22 SUB2008-00073

JOSHUA SUBDIVISION

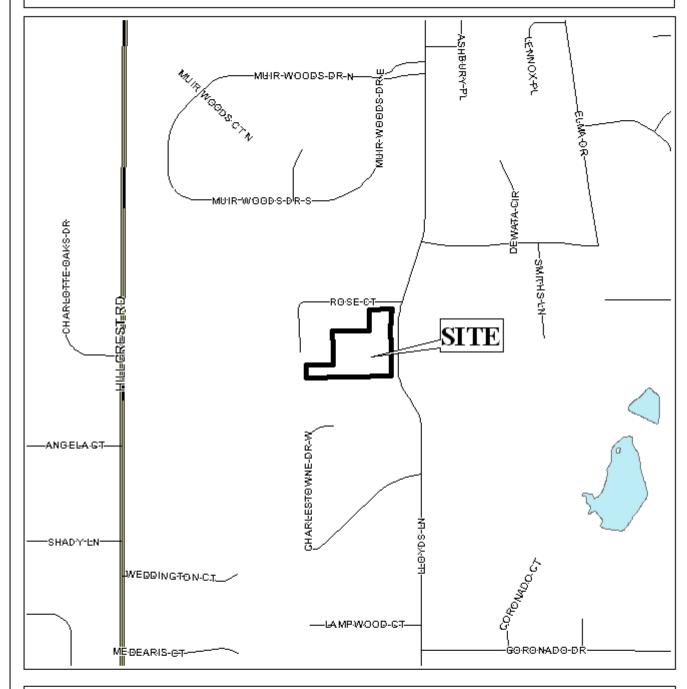
The plat illustrates the proposed 2-lot, $1.7\pm$ acre subdivision which is located at the Southwest corner of Lloyds Lane and Rose Court, extending to the South terminus of Rose Court, in Council District 6. The subdivision is served by public water and sanitary services.

Both lots have frontage on Lloyds Lane with a compliant 50' right-of-way, and Lot 1 also has frontage on Rose Court, with a complaint 50' right-of-way; therefore, no dedication is required. As a means of access management, a note should be required on the final plat limiting each lot to one curb cut to Lloyds Lane, with the size, location, and design to be approved by Traffic Engineering and conform to AASHTO standards. Since the Southern rear portion of Lot 2 has only a single point of contact with the South terminus of Rose Court, a note should be required on the final plat stating that Lot 2 is denied access to Rose Court. The plat illustrates a 25' minimum building setback line along both street frontages and at the Southern rear portion of Lot 2, and these setbacks should also be shown on the final plat.

Each lot is labeled on the plat with its size in acres and square feet. The final plat should also label each lot with its size in acres and square feet, or a table should be provided furnishing the same information.

- 1) placement of a note on the Final Plat stating that each lot is limited to one curb cut to Lloyds Lane, with the size, location, and design to be approved by Traffic Engineering and conform to AASHTO standards;

- 2) placement of a note on the Final Plat stating that Lot 2 is denied access to Rose Court;
- 3) illustration of the 25' minimum building setback line along both street frontages and at the Southern rear portion of Lot 2;

- 4) labeling of each lot with its size in acres and square feet, or the provision of a table on the plat furnishing the same information; and
- 5) placement of a note on the Final Plat stating that development of this site must be undertaken in compliance with all local, state and Federal regulations regarding endangered, threatened or otherwise protected species; and
